PLAN CHANGE 75
TE PUKE FLOODABLE
AREAS AND AREA 3
STRUCTURE PLAN REVIEW
DECISION REPORT

*Western Bay of Plenty
District Council*

April 2017

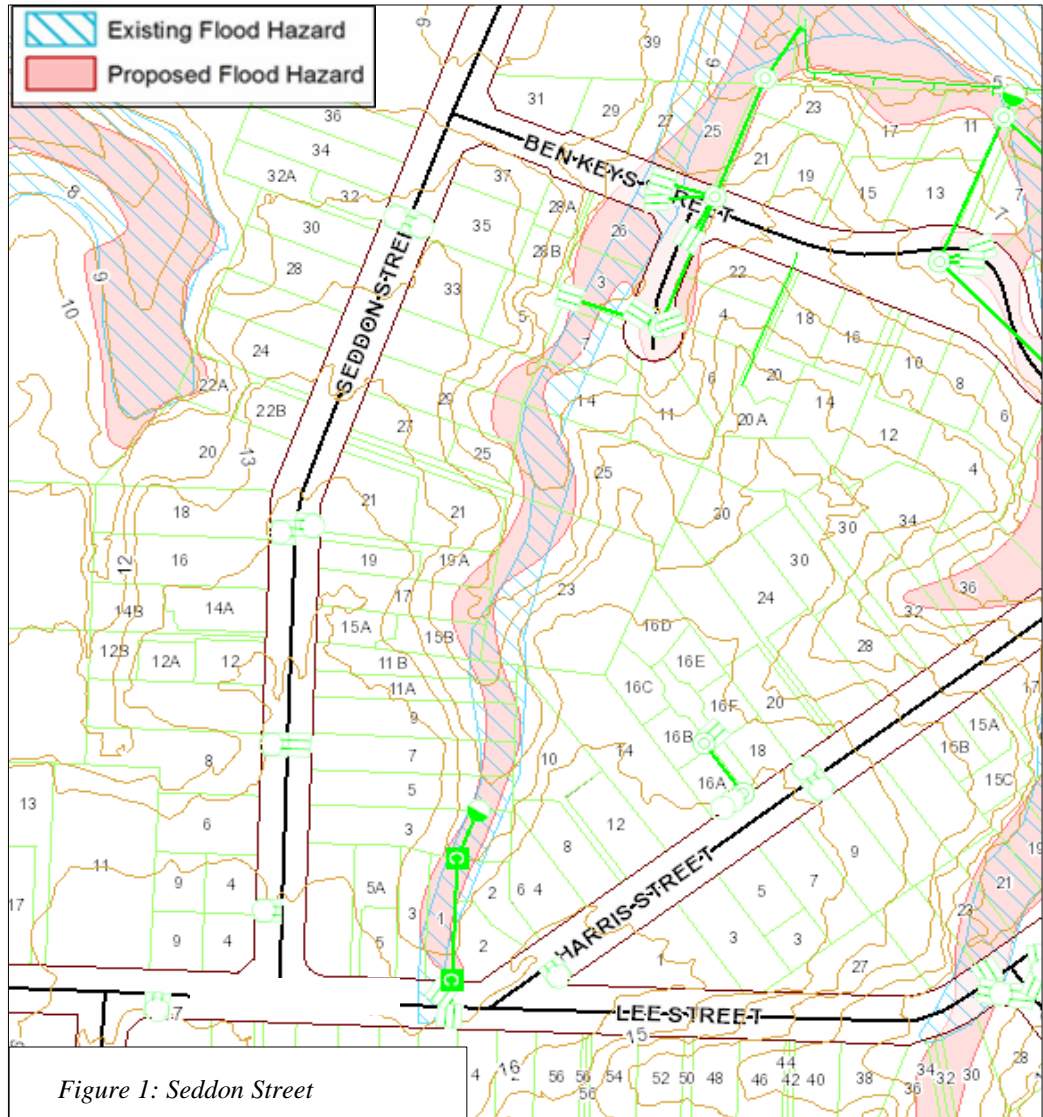
1. The proposed notation on the Upper Cameron Road catchment (figure 1 as follows) be retained as notified.

- a) 134D & E Cameron Road were not included in the notation.
- b) It is agreed that the shared driveway to 152 and 154 Cameron Road has been shaped to channel stormwater.

- c) The model indicates the 675 diameter pipe running underneath the shared driveway has capacity to cope with the 50 year flow. However due to the upstream capacity of the stormwater network (including the catchpits) the 50 year flow does not enter the pipe and instead follows the overland flow path.

- d) A one on one meeting was held in October 2015 with submitter 10 and Council engineers. During the meeting the submitter raised concerns that the proposed flood overlay was incorrect. Staff subsequently visited the site and undertook a spot survey of the section. This information was then used to compare levels in the model which confirmed the potential for an overland flow path over the section. The shared driveway appears to be designed to channel the stormwater flow down the driveway towards the drainage reserve at the back of 152 Cameron Road. This is supported by the model. However, for low frequency storm events (such as the 50 year event) the engineers are of the opinion that the volume of stormwater cannot be contained within the overland flow path and will spill as shown on the new proposed flood hazard overlay.

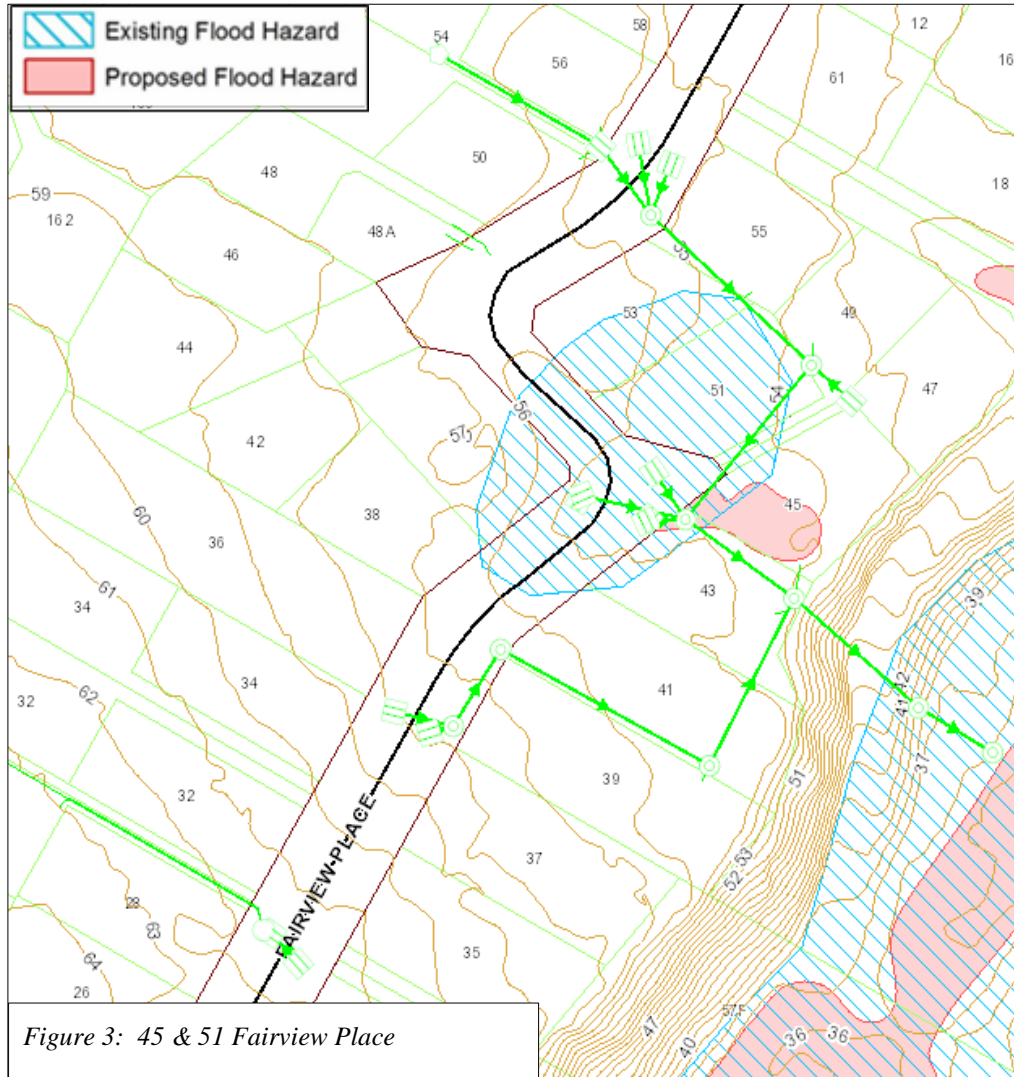
1. The proposed notation east of Seddon Street (Figure 2 as follows) be retained as notified.

- a) The proposed Flood Hazard notation is only a refinement of the operative notation (which is currently included in the District Plan) to align better with the contours.

- b) The notation is along an overland flow path, between Ben Keys Street and Station Road, which is approximately two to four metres lower than Seddon Street.

- c) Two stormwater catch pits are in front of 1 Station Road. These catch pits are linked to a 225mm stormwater pipe (which follows the eastern boundary of 1 Station Road) and discharge the stormwater into the overland flow path that are covered by both the operative and proposed notations.

- d) There is no piped stormwater network along any of the roads within this residential area. As a result all of the stormwater within the area (from both roofs and roads) is managed with soak holes and drains along the overland flow path.

- e) Onsite meetings were held with the land owner at 23 Seddon Street in November 2015 and May 2016. During the meeting a walkover of the property was undertaken. The walkover identified a clear low point at the bottom/back of the property where the storm water would flow over land.

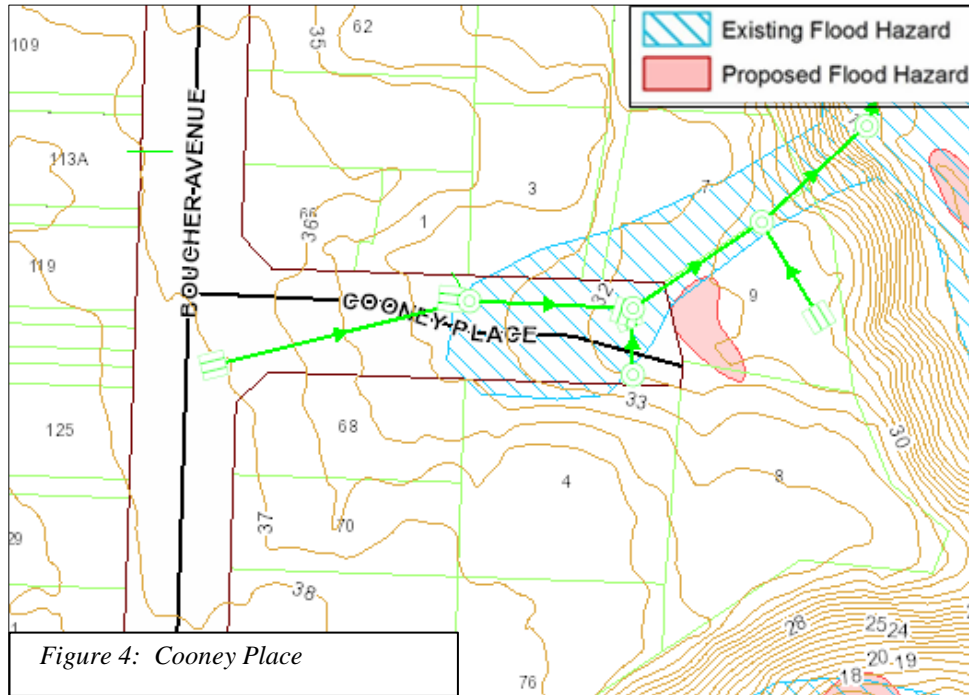
1. The proposed notation on 45 and 51 Fairview Place (Figure 3 as follows) be retained as notified.

- a) The proposed and operative notations are based on a one in fifty year storm event and as a result the existing stormwater infrastructure will not be able to manage the stormwater from such an event.
- b) The model indicates there is potential for water to pond at the end of Fairview Road and at 45 Fairview Place up to depth of 120mm before flowing overland through 45 Fairview Place towards 57a Fairview Place. An extract from the model is shown below. The arrows indicate the direction of flow (smaller arrows indicate less velocity and therefore water ponding). The model indicates the potential for water to pond and flow over land at 47, 49 and 51 Fairview Place, however the depth is less than 100mm therefore it is not shown on the proposed flood hazard maps.

Figure 6: Proposed changes to the notation along the gully to the east of Boucher Ave.

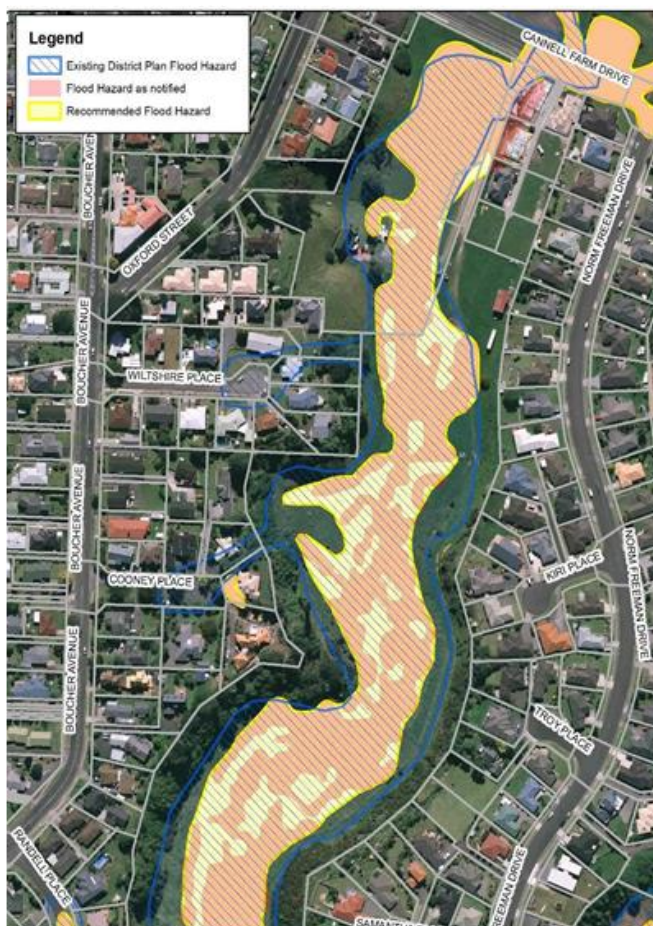
2. The proposed notation along the Main Gully on the eastern side of Boucher Avenue and south of Cannell Farm Drive be amended as per Figure 6 as follows.

- a) Council staff reviewed the model and proposed notation and agree with the comments of Submitter 6. There appears to be local 'highspots' within the gully at which point the water will flow over/around during a flood situation. However, it is impractical to exclude these from the flood hazard notation.
- b) It is important to note that as part of the review Council is required to respond to issues of climate change under government legislation. As such a 50 year storm event taking into account climate change up to the year 2090 has been incorporated into the new floodable areas. It is also important to keep in mind that it is standard practice that existing infrastructure mainly deals with a one in five year storm event.

Figure 8: 34 Oxford Street

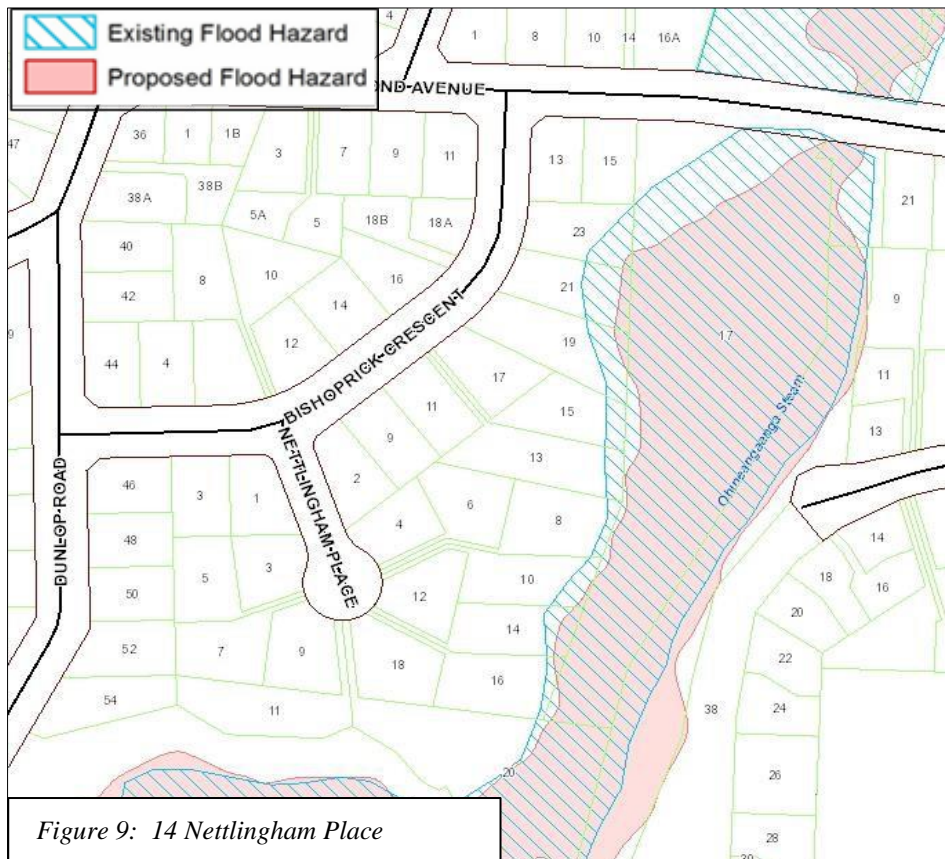
- 1. The proposed notation on 34 Oxford Street (Figure 8 as follows) be retained as notified.

- a) The road crossing and driveway were constructed in a way that allows stormwater from Oxford street to enter the property easily during a storm event and will flood the garage and downstairs component of the dwelling.
- b) The risk of flooding can be reduced by the submitter by changing the profiling of the vehicle crossing. Council's Utilities Team and Transportation Operations Manager will assist with the design. The notation needs to be retained until the work has been completed.

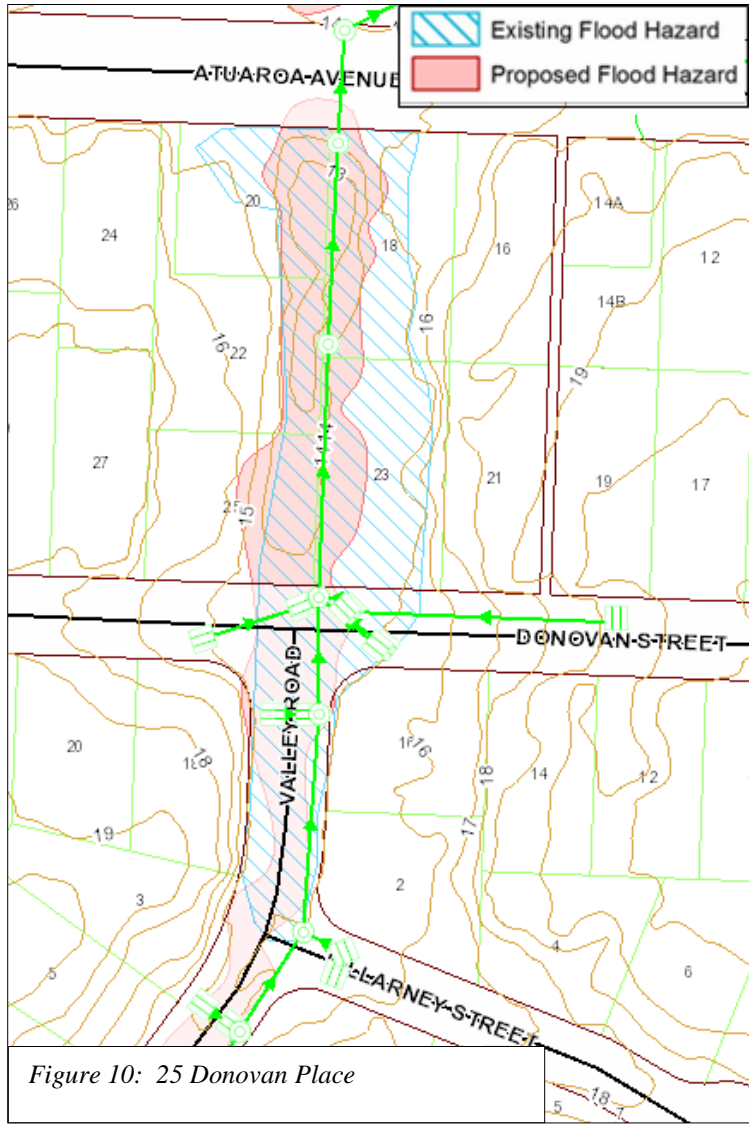
- 1. The proposed notation (Figure 9 as follows) be retained as notified

- a) The notation is based on a one in fifty year storm event and on the assumption that debris may block the primary stormwater path. The submitter is thus correct in saying that the Raymond Avenue bridge is not designed to deal with a storm event of that extent. That is the reason for including the notation in the District Plan. To upgrade stormwater infrastructure to manage the one in fifty year storm event as a primary system will be unaffordable and is not standard engineering practice in New Zealand.

- b) A project is included on Council's 2017/18 work programme to investigate options to reduce erosion and debris coming down the Ohineangaanga Stream.

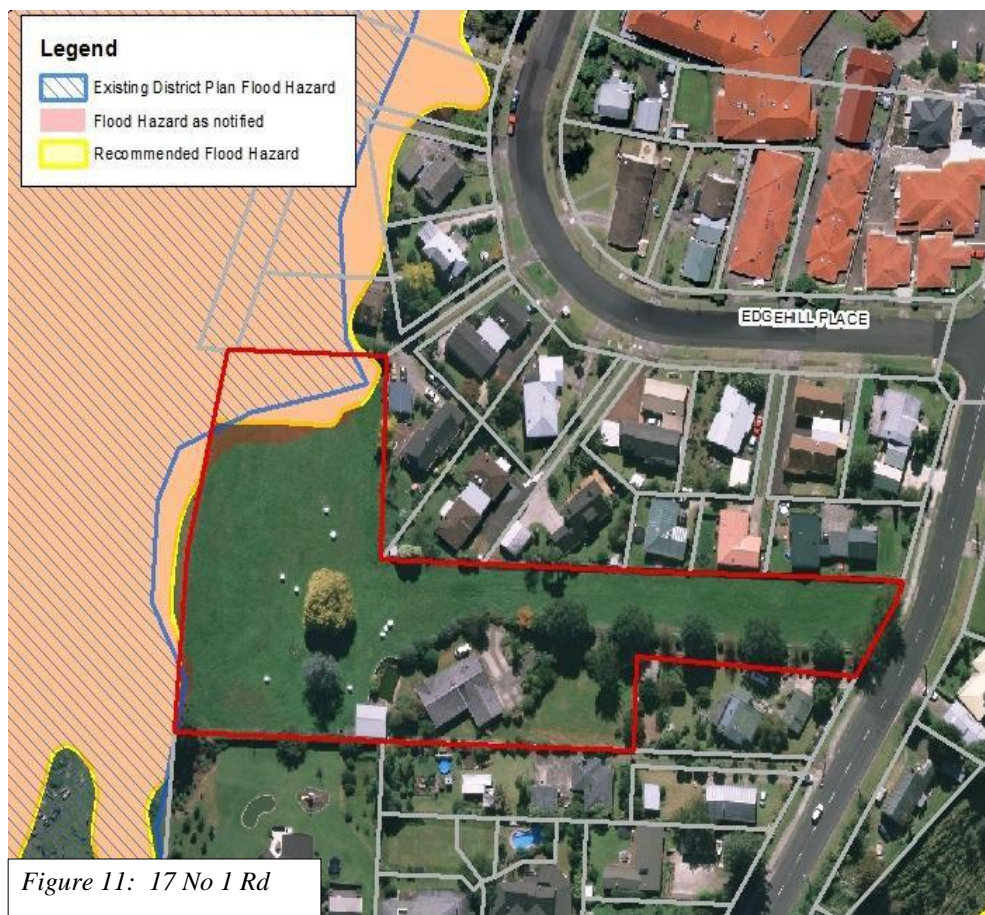
1. The proposed notation on 25 Donovan Street (Figure 10 as follows) be retained as notified

- a) The notation is based on a one in fifty year storm event. The lower lying area between Donovan Street and Atuaroa Avenue, which includes 25 Donovan Street as an important overland flow path needed to manage stormwater during a storm event greater than a one in five year event.
- b) The existing cache pits were installed to mitigate flows from Donovan Street.
- c) Staff will meet with the submitter to discuss stormwater flows.
